# SERVICE BULLETIN

## KODAK X-OMAT Processor

SERVICE BULLETIN NO. 218

### **Replacement T ROLLER for the DEVELOPER RACKS of All PROCESSORS** **Listed Below**

Figure 0-1

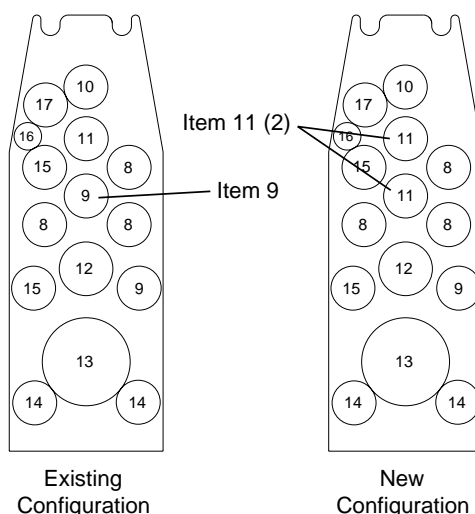
## Change in the Parts List for the M7B PROCESSOR DEVELOPER RACK

See the illustration and table below and make corrections to the M7B Parts List, Publication No. 981160. There are two Stainless Steel ROLLERS in the M7B DEVELOPER RACK, shown below as Item 11 in the New Configuration diagram.

Processor	Pub No.	Page No.	Figure No.	Item No.	Part Description	Existing Qty.	Change to Qty.
M7B	981160	4-3	4-1	9	C ROLLER ASSEMBLY	7	6
				11	T ROLLER ASSEMBLY	1	2
		4-15	4-8	1	C ROLLER ASSEMBLY	2	1
				3	T ROLLER ASSEMBLY	1	2
